HOUSTON LIGHTING AND POWER COMPANY
SOUTH TEXAS PROJECT ELECTRIC GENERATING STATION
PLANT PROCEDURES MANUAL

Work Process Program*

OPGP03-ZA-0090*

Rev. 10 (General)

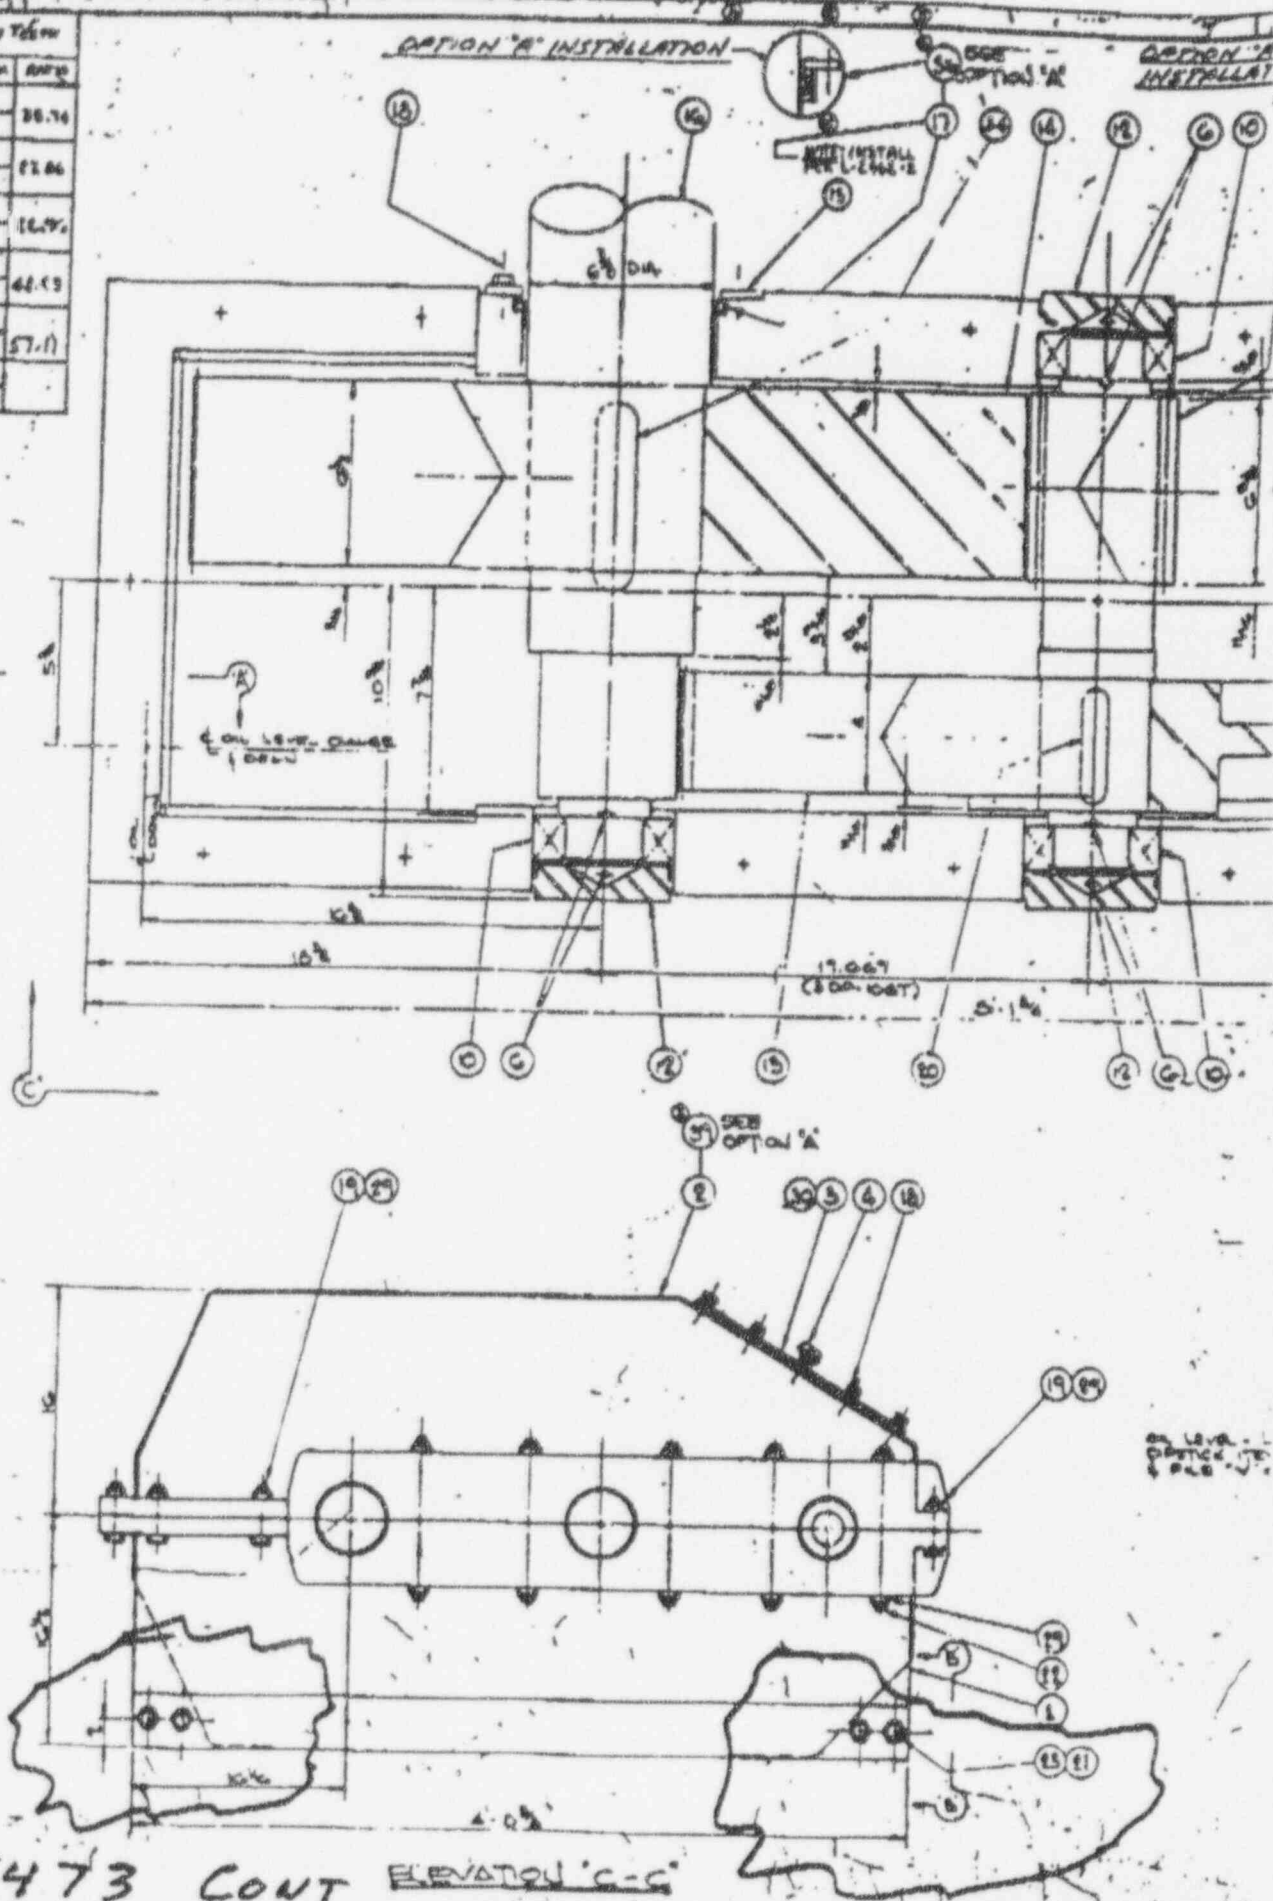
As requested, attached are a set of marked drawings (U-77587 & U75473) and copies of the pages in Whiting's Bill of Materials (BOM) (Reqn. 68919, page 13 of 126, and Reqn. page 13 of 126) which identifies the Main Hoist Unit support bolts that were in question.

Therefore, based on this information and the results of an engineering review, it is recommended that for the scheduled lift of 310 Tons on 3/10/94, the two hoist unit support bolts in the corner identified as '1' on the attached marked drawing U-77587, be replaced with A325 bolts (3/4" diameter 2-1/2 or 2-3/4" long) on crane S/N 11256. Since these bolts are in tolerance holes, the replacement bolts must be tolerance bolts (see attachment L-2695-1). When installing them, the bolts should be torqued to 200 to 230 foot-pounds. The bolts in the other three corners need not be replaced at this time, but they should be checked for tightness (200 to 230 foot-pounds of torque for A325 bolts and 130 to 150 foot-pounds of torque for the unmarked bolts). In the future, the remaining unmarked bolts will need to be changed before using the main hoist for loads greater than 310 Tons.

In evaluating the polar crane's capacity to accommodate the reactor head lift, Whiting has recommended that some bolts be changed out on a gear box on the main hoist. PCF 157308A was issued on March 9, 1994 to change out the bolts in Unit 2 as recommended by Whiting.

Upon completion of the bolt change out per the referenced PCF, DED recommends that the main hoist on the Unit 2 polar crane be considered operable for up to 310 ton lifts based on recommendation from Whiting. Lifting for additional loading is not recommended at this time.
